Will the repair of the Cairngorm Funicular Railway work (2)?

In the first part of this series of articles ([see here](#)), about whether the repairs Highland and Islands Enterprise (HIE) has planned for the funicular will work, the following picture was thought to be that of a pier base.

Figure 2-10 Loosened rock bolt in anchor block (refer defect 7)

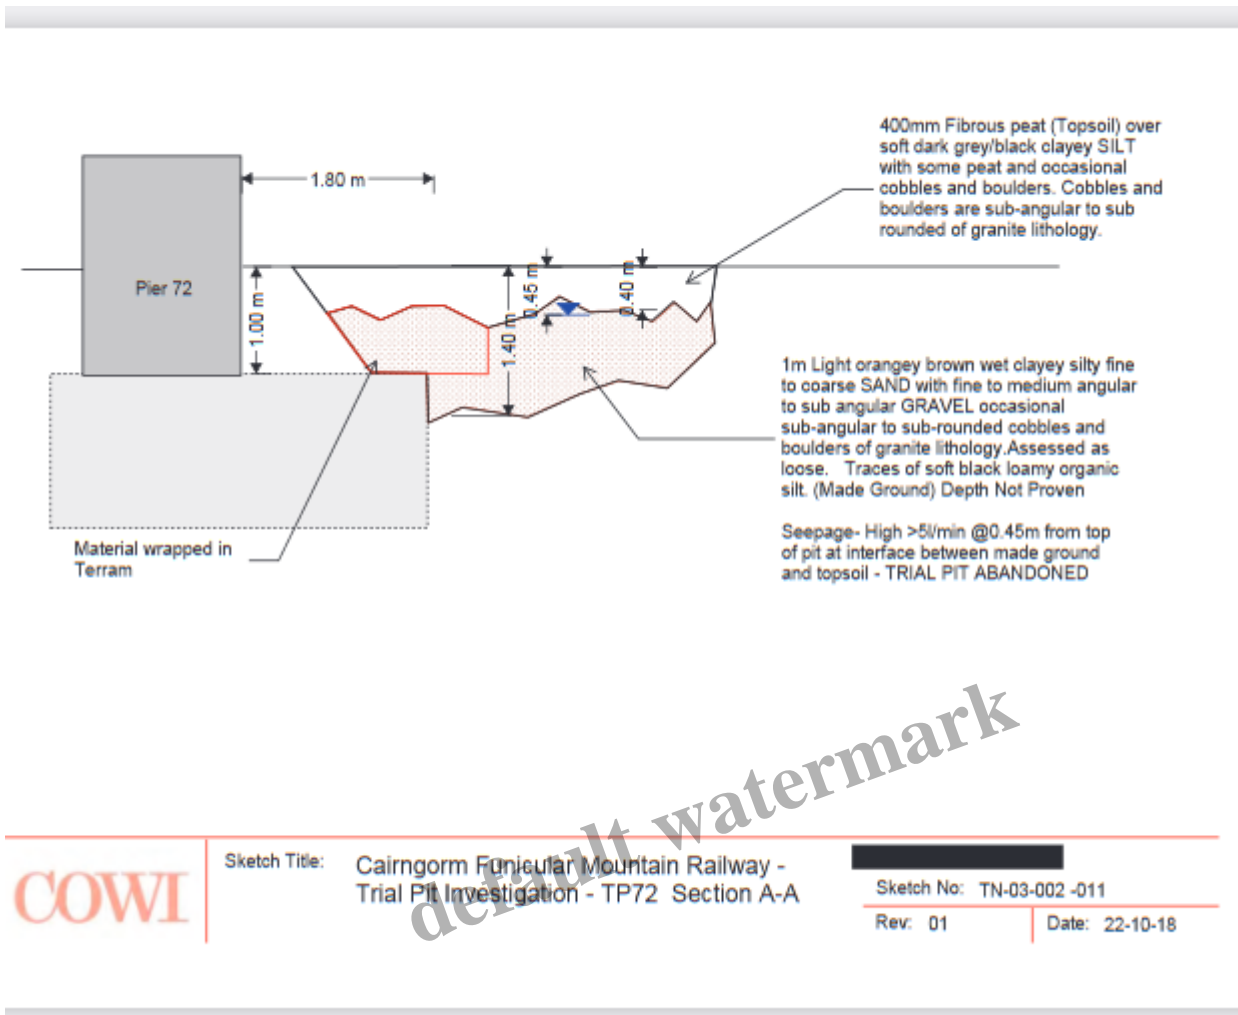
Question (1) Where was the routine maintenance schedule that should have been carried out by maintenance staff that allowed this to happen?

Question (2) Is it possible to tighten this bolt taking into account the corrosion on the threads?

It is not known which of the Anchor Blocks this is, or how many of its securing bolts were loose, but these bolts are there for a reason. These Anchor Blocks take the weight/ strain of the approx. 2 x 300m of uphill concrete beams, which are continually trying to slide downhill under the force of gravity. They should be checked on a regular basis and the nuts torqued to a specific setting. Depending on how many of the bolts on any one Anchor Block were loose, the one below it could have been carrying the full weight of 600m of track! You can see from the corrosion on the rock bolt that the nut has been loose for some time.

Question (3) Why was this not noticed at previous inspections?
